UNITED STATES  
NUCLEAR REGULATORY COMMISSION  
REGION V

SUBJECT: RANCHO SECO TURBINE AND FEEDWATER REACTOR TRIP MODIFICATIONS

REACTOR TRIP SCHEME

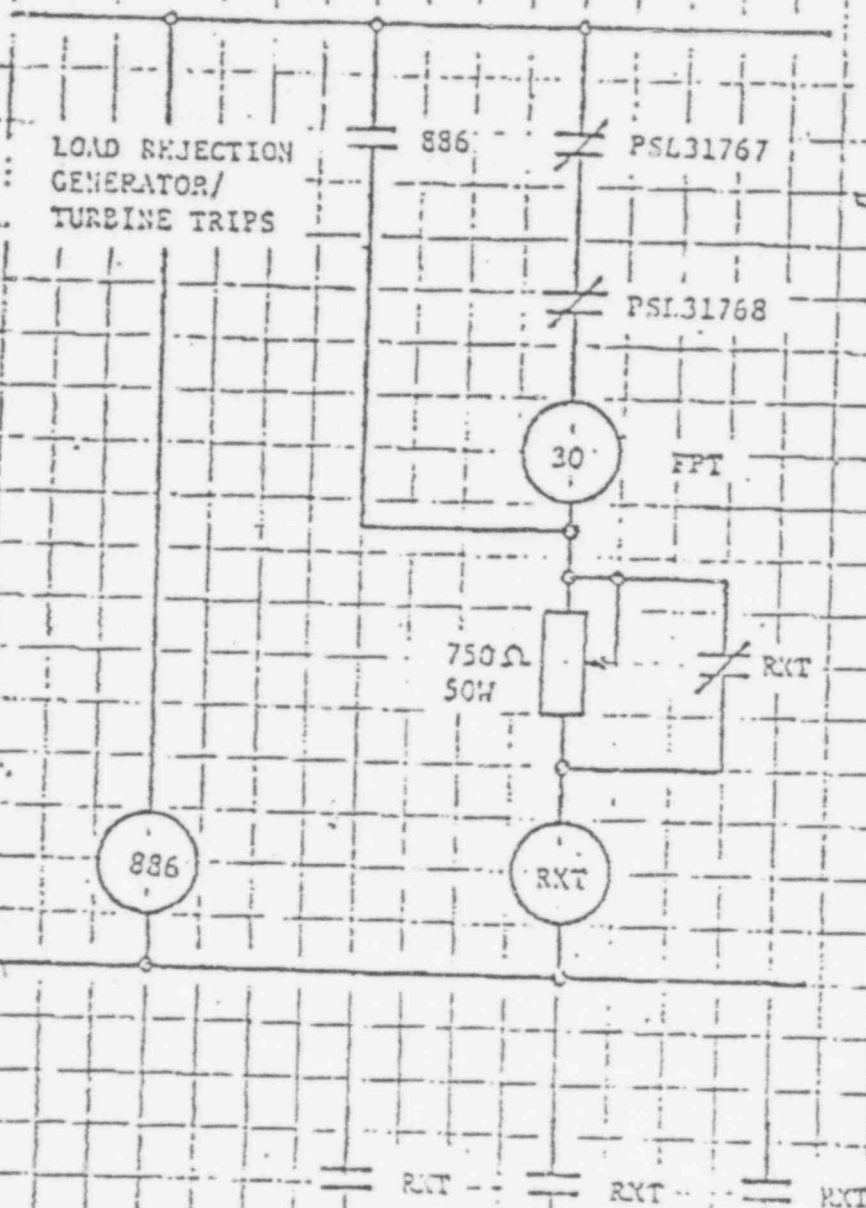
In a letter to Harold Denton dated May 14, 1979, SMUD described the design of the above identified trips. Attached to the letter was a simplified drawing of the trip circuit which is being submitted as Enclosure A. As shown in this drawing, the two feedwater pressure switches PSL 31767 and PSL 31768 are in series which requires the loss of both feedwater pumps to initiate a reactor trip. The circuit is designed such that the pressure switch contacts must close to energize the reactor trip relay (RXT).

Even though it is understood the trip circuits are to be installed as control grade circuits, Region V is concerned that the non-fail safe design (need-to-energize) may be less reliable than intended by the Commission's Order.

The Principal Inspector at Rancho Seco (Mr. Al Johnson) has expressed serious reservations regarding the non-fail safe design. He recommends that the licensee be required to modify the circuit to make it fail safe.
